Supplement to comment 2762

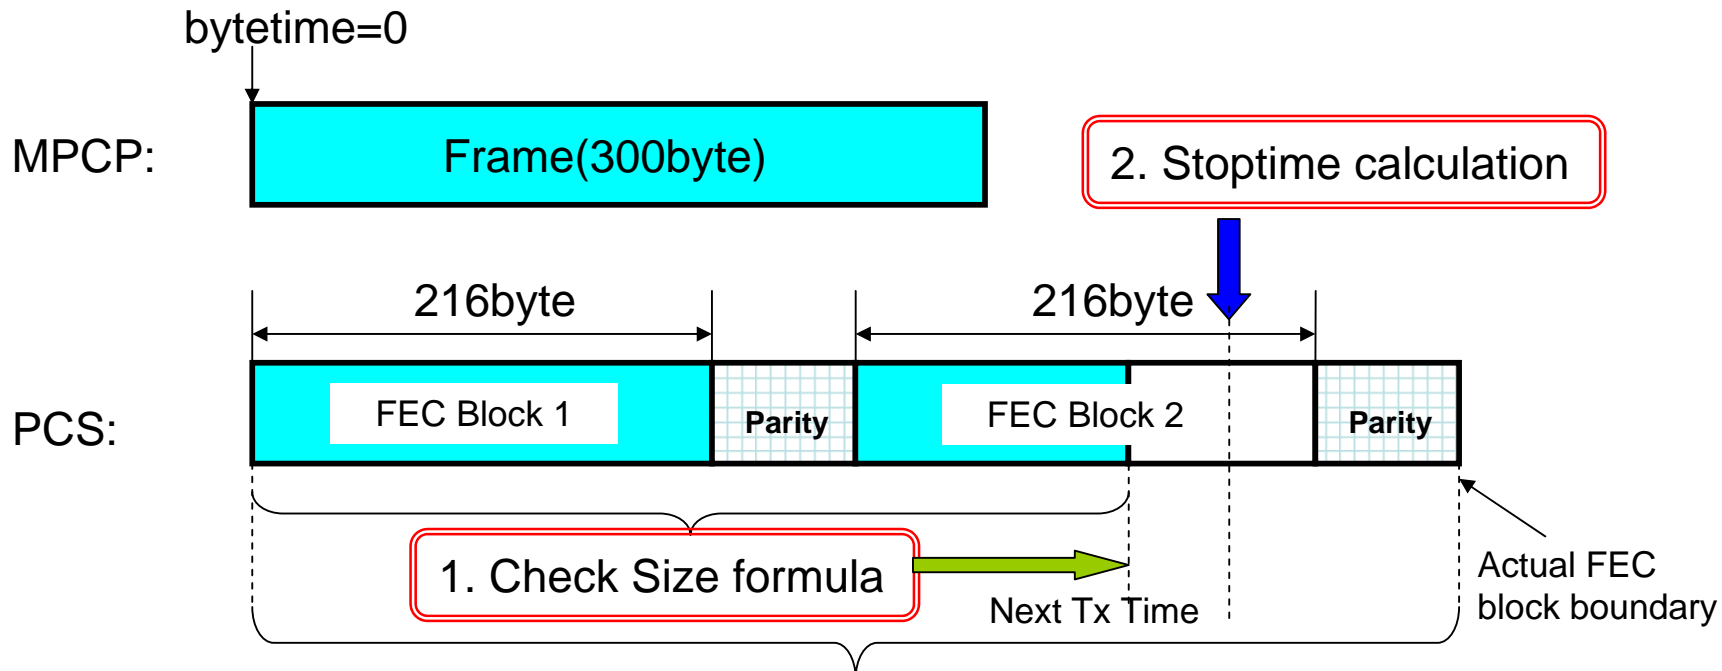
The issue : In case of transmitting a frame of 300 bytes length (for example), a bad situation may happen as follows.

1. Formula in Check Size state of Figure 77-14 returns 1 parity block. And it determines this frame could transmit completely.
2. The stoptime is calculated in Figure 77-30. It's not clear that the stoptime comes after the actual FEC block boundary.

This frame needs two FEC blocks for transmission actually.
